White Salmon Planning Commission Meeting
A G E N D A
May 13, 2026 – 5:30 PM
119 NE Church Ave and via Zoom Teleconference

Type II Site and Building Plan Review. A proposal for a multiplex residential use with four (4) dwellings on a 6,012 sq. ft. parcel in the R2 zone, located at 130 SE Wyers Street, planning file WS-SPR-2026.002.

TYPE II STAFF REPORT FOR SITE AND BUILDING PLAN REVIEW

Parcel Number: 03111972021300
Legal Description: LOT 10 BLK 2 ORIGINAL TO WS SWSW 19-3-11
Planning File: WS-SPR-2026.002

DATE: (REVISED) NOVEMBER 18, 2024
PROJECT: 24125SITE/MP
SCALE: 1" = 20'
PARCEL No: 03111972021300

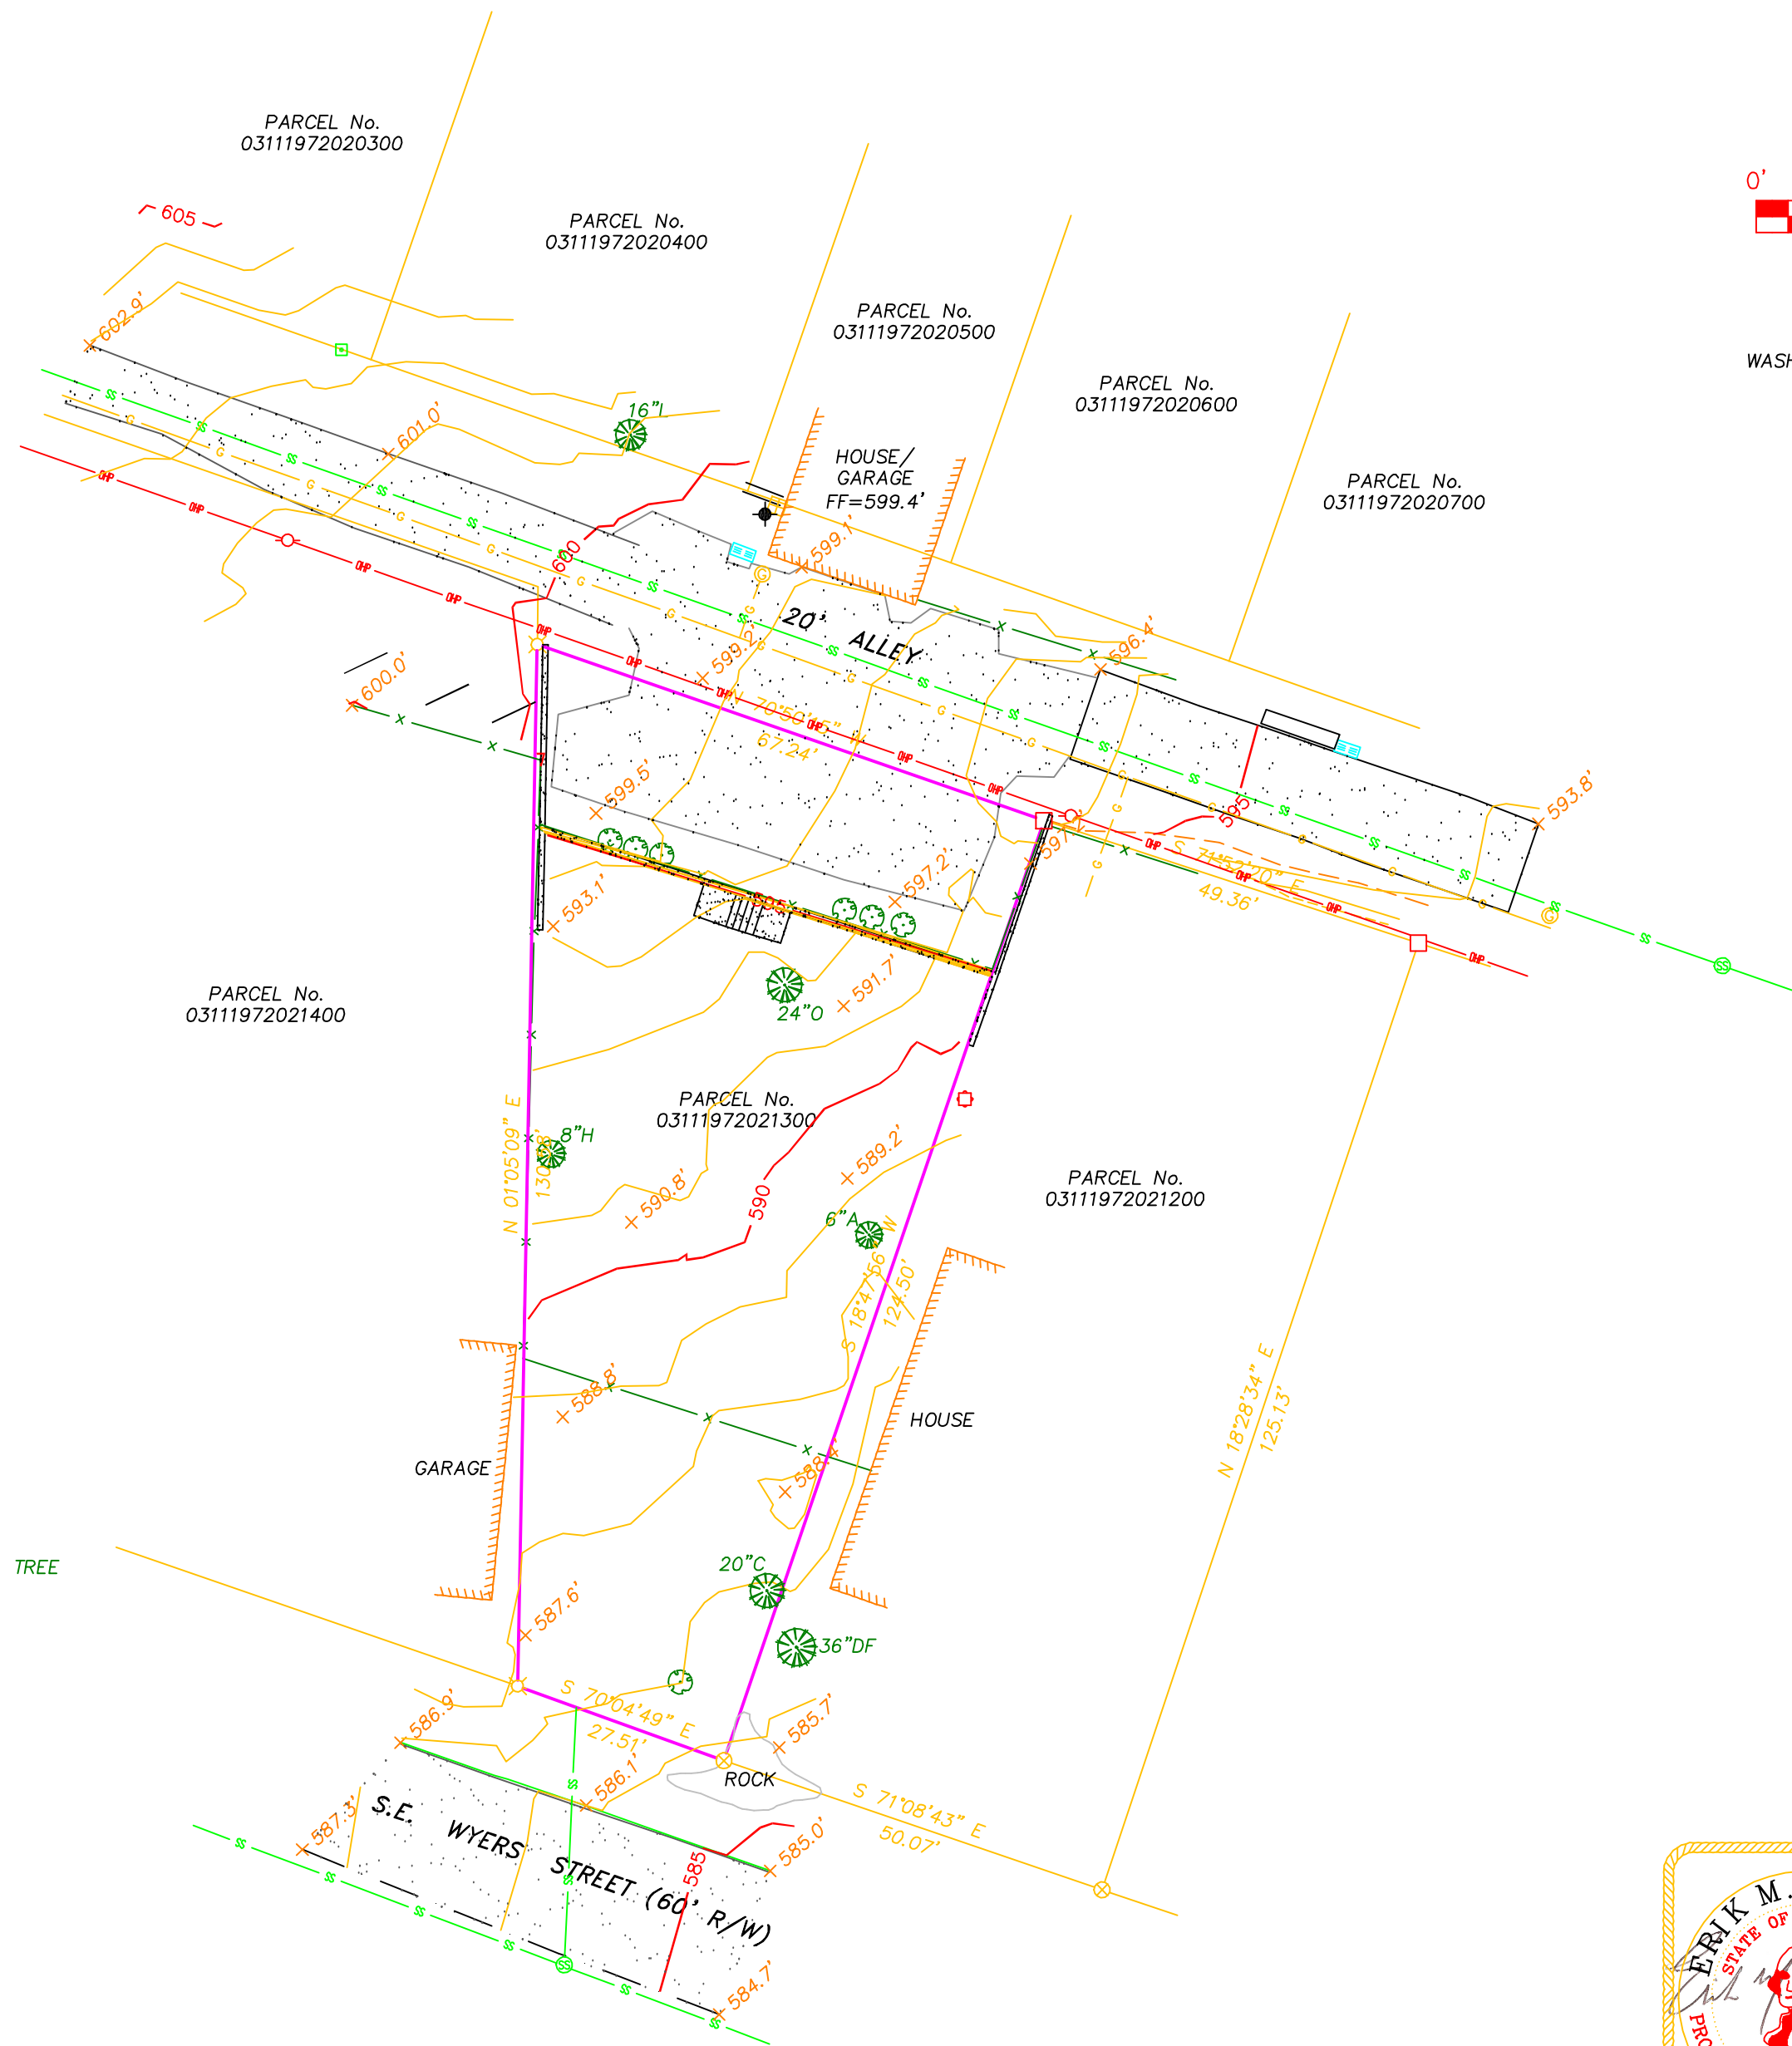
Units “A” and “B” are over 800 sq feet and require 2 parking spaces each, while Units “1” and “2” are under 800 sq feet and require 1 parking space each, for a total of 6 parking spaces. The site plan shows 4 parking spaces with dimensions of 10’ by 19’ in the alley, and 2 parking spaces in the front yard, with dimensions of 11’ by 20’. This standard is met.

Condition of Approval: The applicant shall either install permeable pavers for the driveway and parking area off Wyers, or shall install typical impervious pavement and accommodate that increased stormwater runoff in its stormwater facility calculations and plans.

This development will connect to public sewer, as shown on the site plan, and no septic system is proposed. Per the Public Works department, sewer connections are available from SE Wyers St.

This development will connect to public water, as shown on the site plan. Per the Public Works department, water connections are available from SE Wyers St.

5. The applicant shall either install permeable pavers for the driveway and parking area off Wyers, or shall install typical impervious pavement and accommodate that increased stormwater runoff in its stormwater facility calculations and plans.
